TECHNICAL MEMORANDUM

Project No. CA0042515.2530

RE: LAFARGE GOODWOOD EXTENSION PIT – WSP RESPONSES TO BURNSIDE HYDROGEOLOGY PEER REVIEW COMMENTS

TITLE
MECP WATER WELL CROSS-SECTION A-A'

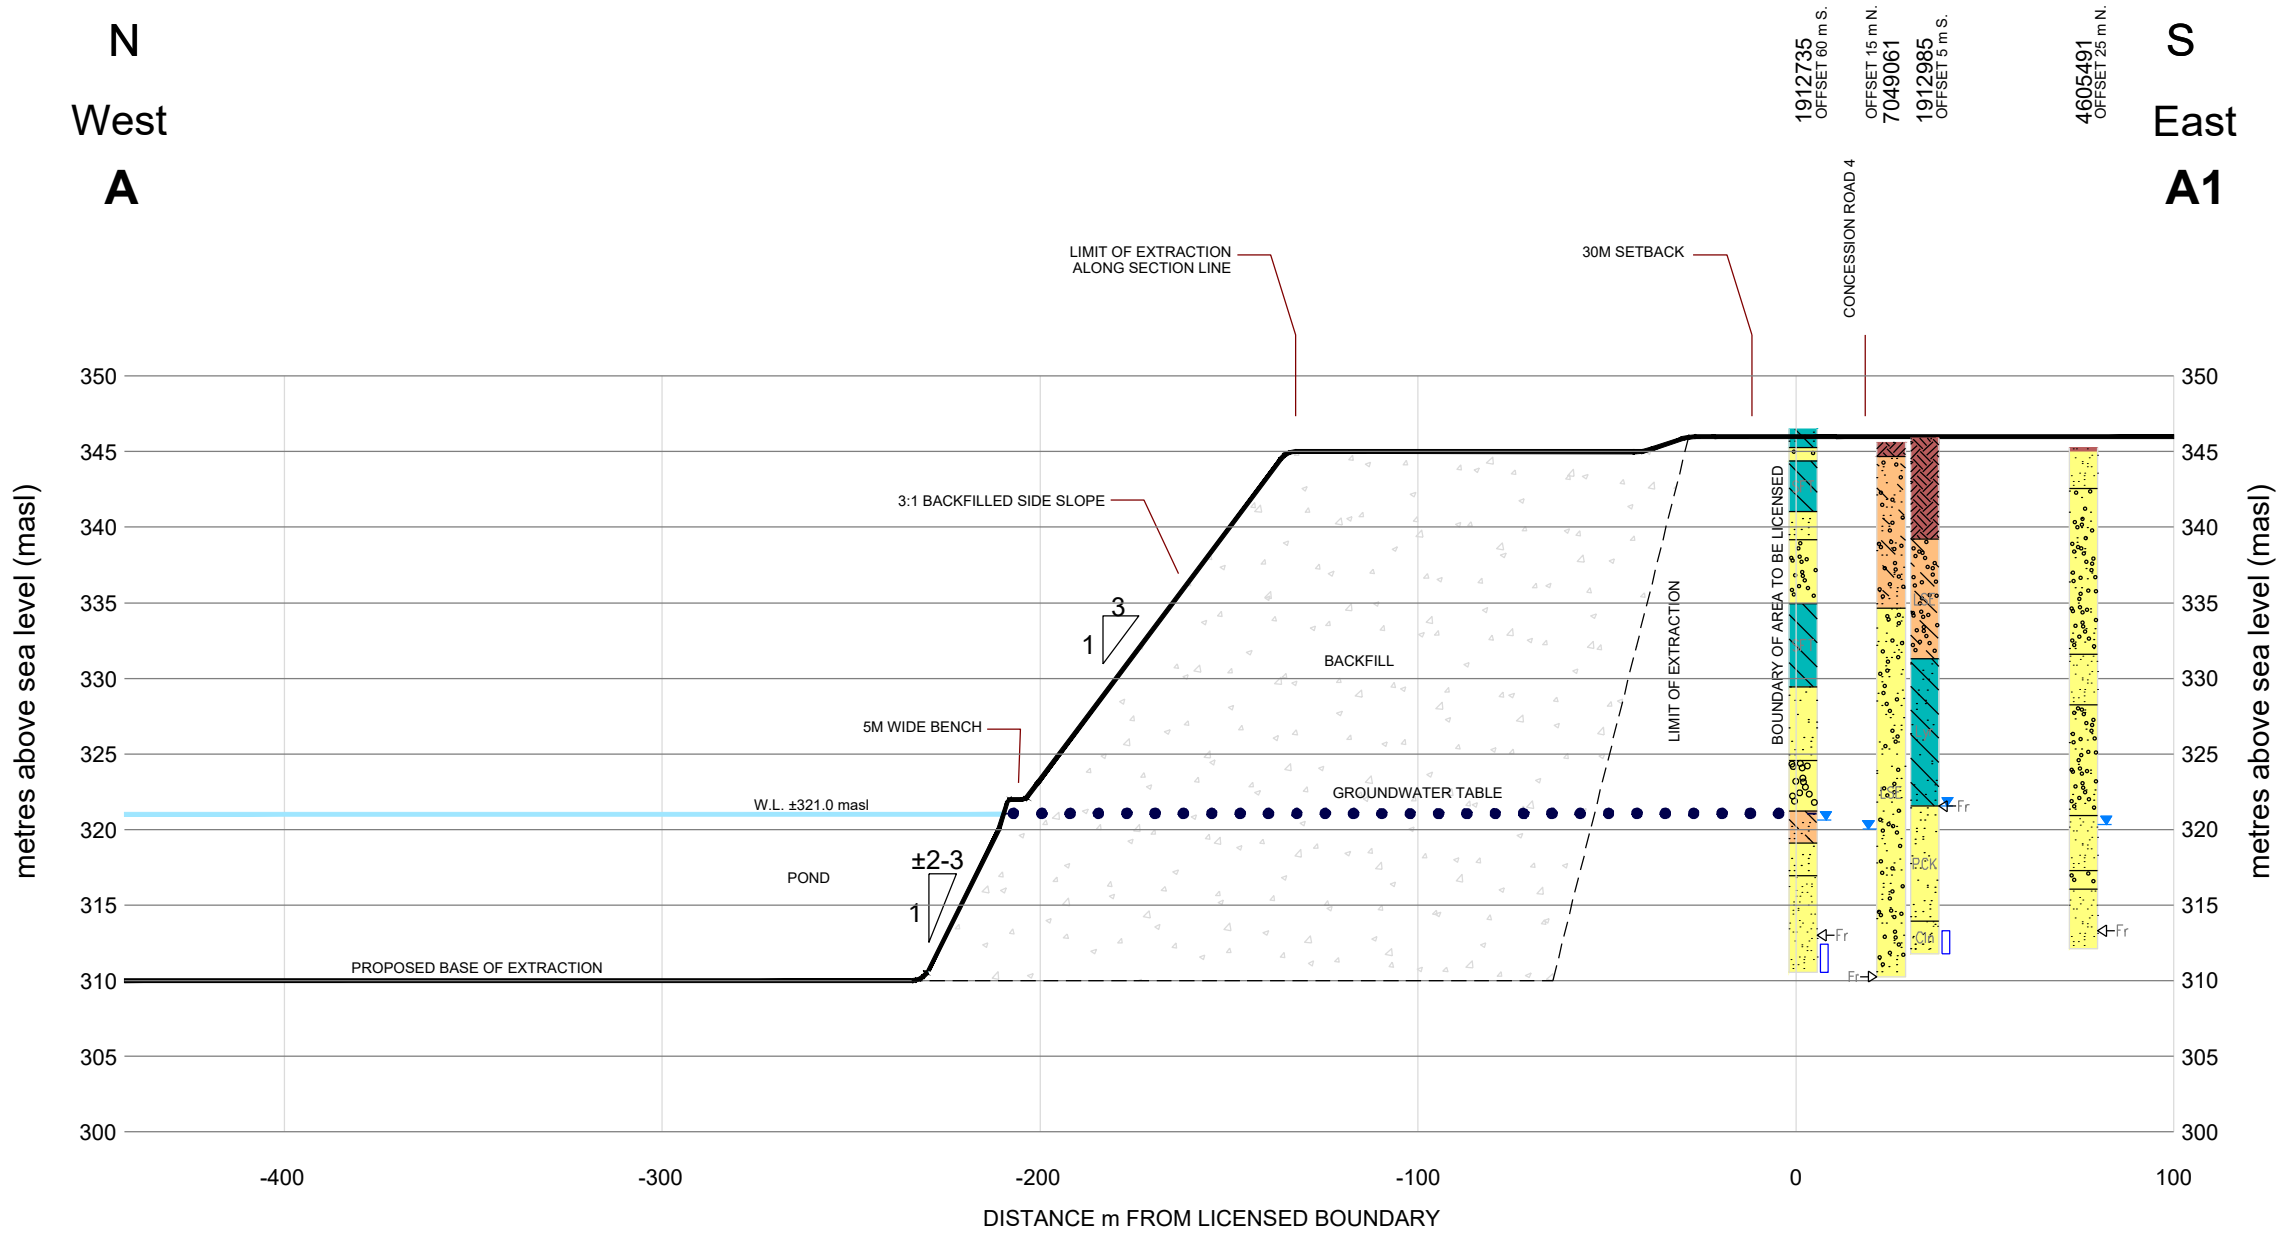
WSP should provide some commentary on the potential water quality impacts to groundwater (and domestic wells) because of wildlife using the ponds created by the aggregate extraction. WSP should indicate whether there is potential for coliforms, cryptosporidium and giardia to enter the aquifer. Additional cross sections should be prepared to show the relationship between the pond that will be created and the nearby domestic wells.

As requested WSP has prepared the attached cross section to show the relationship between the pond that will be created and the near by domestic wells.
